## **RFCSP 14-02**

### **AUSTIN STREET IMPROVEMENTS & SAN JACINTO MEMORIAL GREEN (SJMG)**

#### **Contractor Questions & AE Responses:**

##### **RFI#5**

**15** TYPICAL 25-FOOT  
POLE FOUNDATION  
SCALE: 3/4"=1'-0"

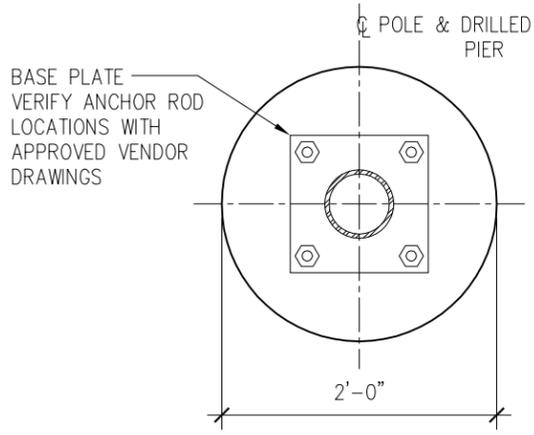
2. Re: Drawings SE300 and CS-3.01 (SanJac project)

The light pole foundations are designed for 16' poles.

Fixtures 'CC' and 'DD' have 25' poles.

Is the structural foundation design adequate for the taller poles?

***AE Response: Please find new drawing for Typical 25-Foot Pole Foundation as part of Arch Addendum 002.***

DESIGN IS BASED UPON A 25-FOOT POLE WITH A MAXIMUM OF THREE FIXTURES (13.2 EPA EACH) WITH BRACKETS AND FOR A WIND VELOCITY OF 110 MILES PER HOUR 3-SECOND GUST, USING EXPOSURE C AND IMPORTANCE FACTOR OF 1.0.
